SIB 52 19 23

SECOND ROW 60/40 SEAT RAIL FLEX CABLE REPLACEMENT

This Service Information Bulletin (Revision 4) replaces SI B52 19 23 **dated January 2026**.

What's New:

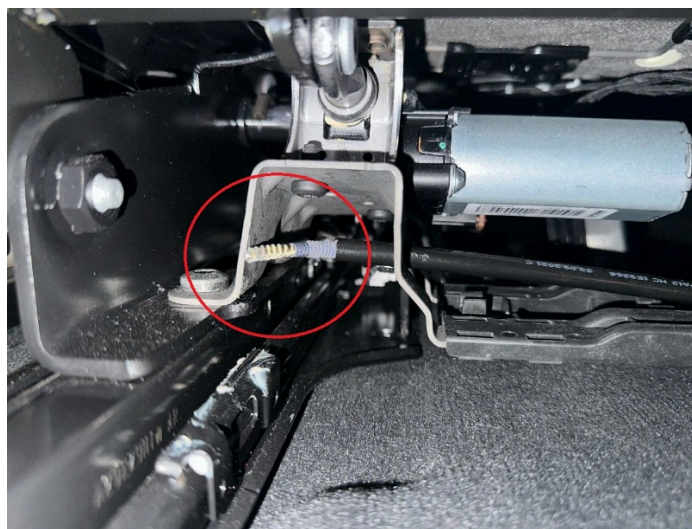
- Parts Section – Part Number 52 20 5 A9C 055 Cable Lengths added
